Technical Service Bulletin

94 "Electrical system fault" is displayed in the instrument cluster, DTC: P18F100, P0A1B00, U140500
94 22 60 2068617/1 November 18, 2022.

Model(s)	Year	VIN Range	Vehicle-Specific Equipment
Q4 e-tron, and Q4 Sportback e-tron	2022	All	Not Applicable

Figure 1: 10 Pin connector.

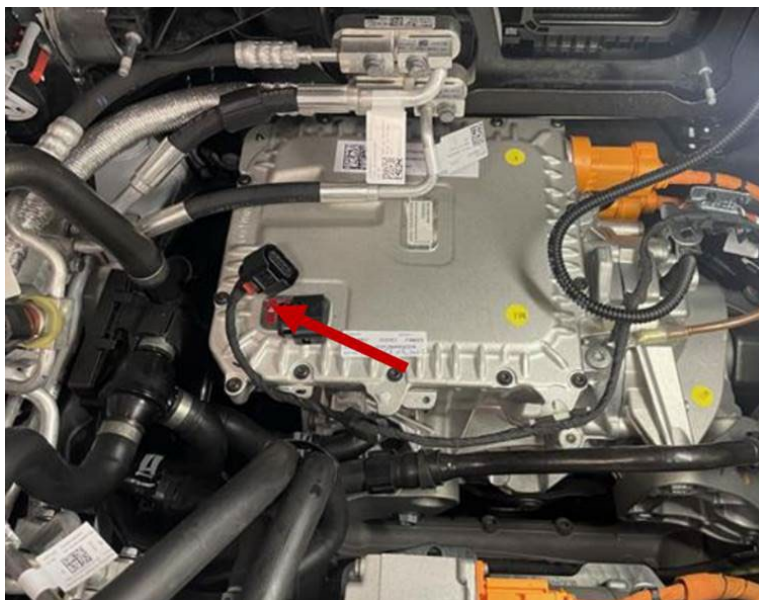
Inspect connector T10 at power electronics 2 for electric drive JX4 for spread or damaged contacts:

If any damage is found to the pins or connector, replace the 10-pin connector and associated wires/pins.

Note: **DO NOT** de-pin the connector. Cut the connector off the harness leaving approximately 5cm of the harness attached to the connector. Retain the connector and harness section for analysis.

Replace the connector and repair the harness using **VAS 1978B**.

In the warranty claim ensure part number **4H0 973 715 A** is claimed as the causal part.
